RE: Timberline Storage Yard
Private Detention/Stormwater Quality Pond

AS-BUILT

TIMBERLINE STORAGE YARD

POND 1 WATER QUALITY OUTLET STRUCTURE
NOT TO SCALE

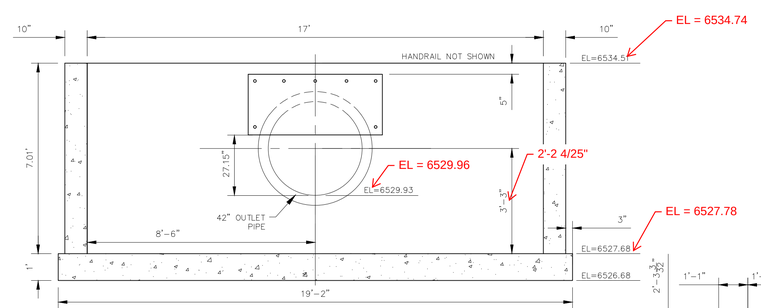
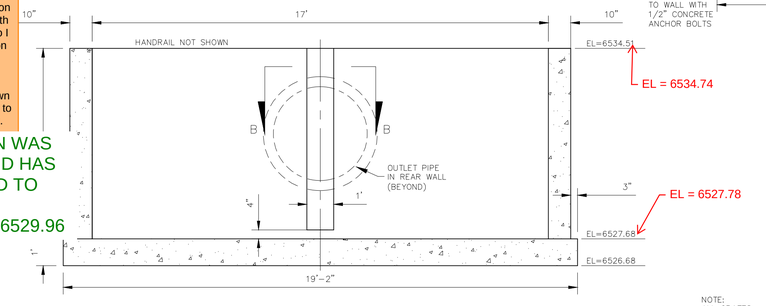
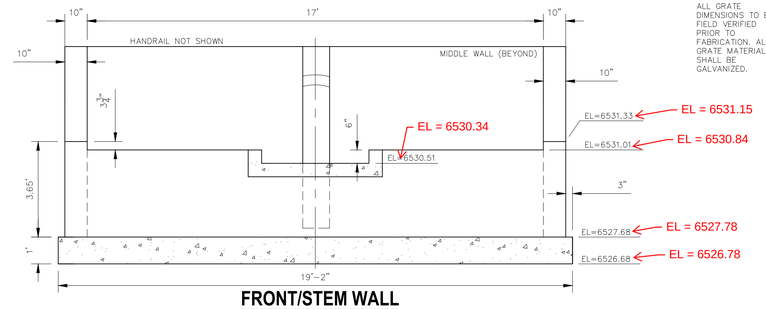
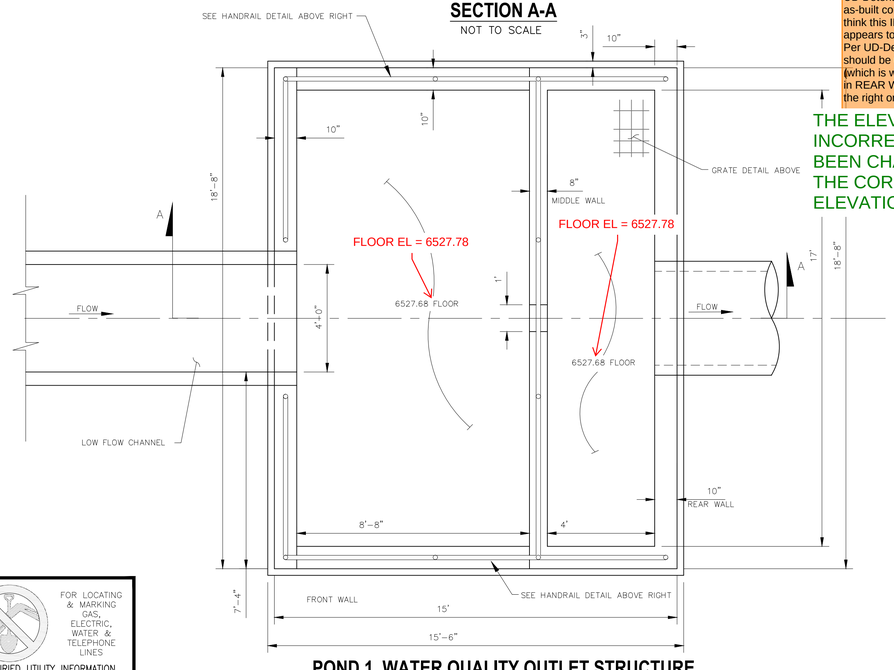
Depth below Stage=0ft shown as only 0.46ft on UD Detention form with as-built conditions. So I think this INV elevation appears to be a typo. Per UD-Detention it should be 6529.96 (which is what is shown in REAR WALL detail to the right on this sheet.

THE ELEVATION WAS INCORRECT AND HAS BEEN CHANGED TO THE CORRECT ELEVATION OF 6529.96

FULL SPECTRUM DETENTION POND OUTFALL
NOT TO SCALE

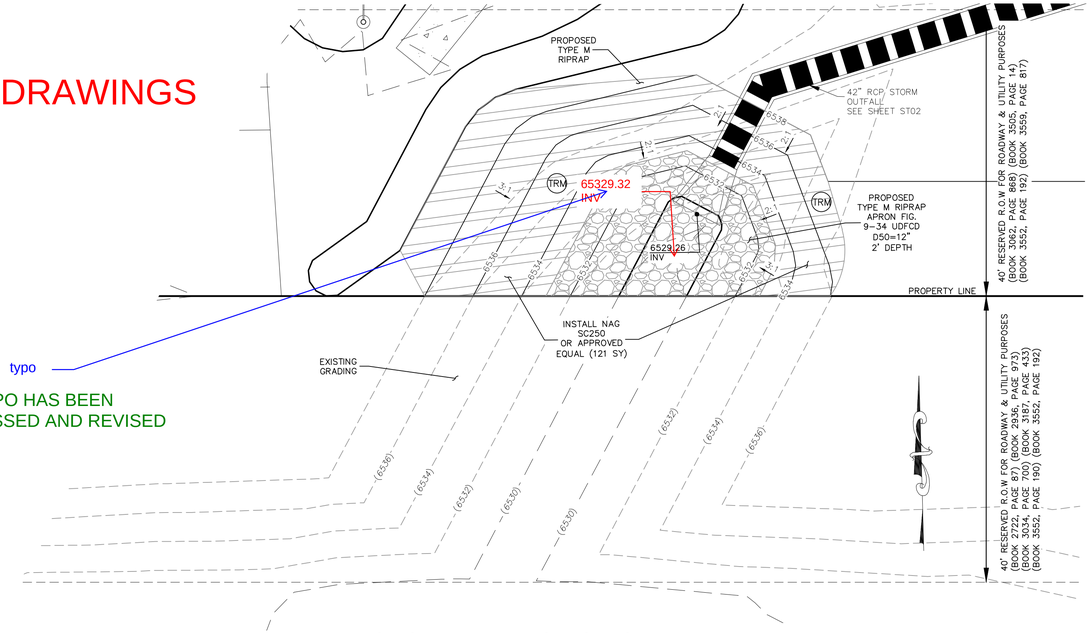
typo

THE TYPO HAS BEEN ADDRESSED AND REVISED

FULL SPECTRUM DETENTION POND 1
SOUTHEAST LOW TAILWATER RIPRAP BASIN
NOT TO SCALE

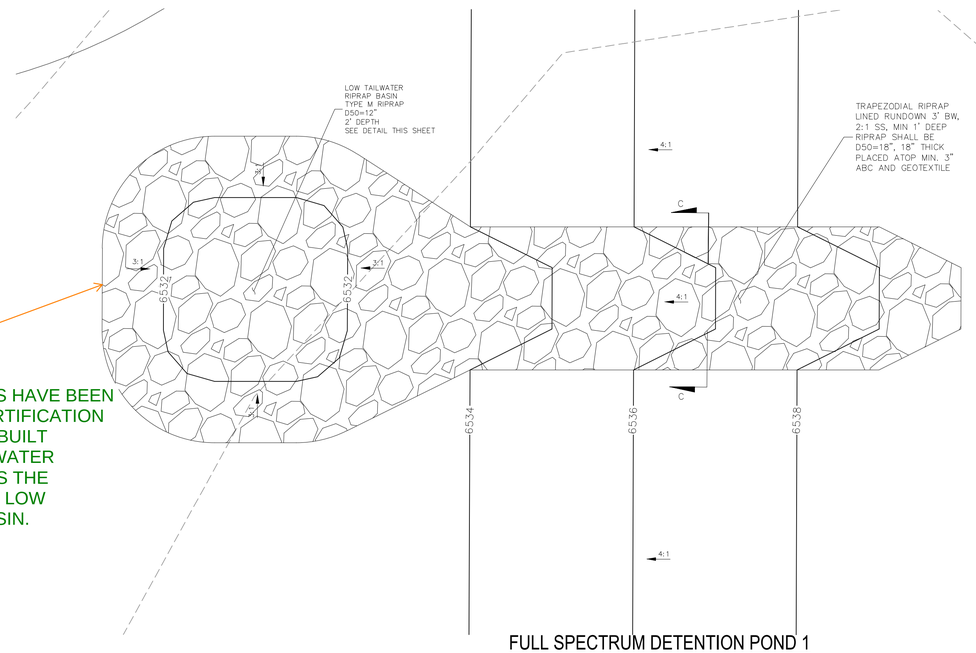
Per comment on the FA Punchlist, the length of the basin was only 17ft in the field. Plans state it should be 24ft. Consider if this is acceptable and reflect changes on these as-builts.

THE AS-BUILT CHANGES HAVE BEEN REFLECTED IN THE CERTIFICATION PACKAGE AND THE AS-BUILT SOUTHEAST LOW TAILWATER RIPRAP BASIN EXCEEDS THE DESIGNED SOUTHEAST LOW TAILWATER RIPRAP BASIN.

SECTION A-A, EMERGENCY SPILLWAY
NOT TO SCALE

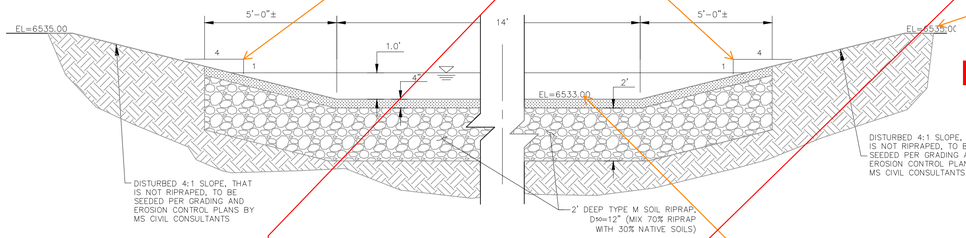
Shown as 10:1 on UD Detention spreadsheet. Revise to remove discrepancy.

Revise. Should be higher than spillway crest. Freeboard 0.67' per UD Detention spreadsheet.

Height above Stage=0ft shown as 8.08ft on UD Detention form with as-built conditions. So per UD-Detention this should be 6538.50 (which is what is shown in plan view on ST03 above).
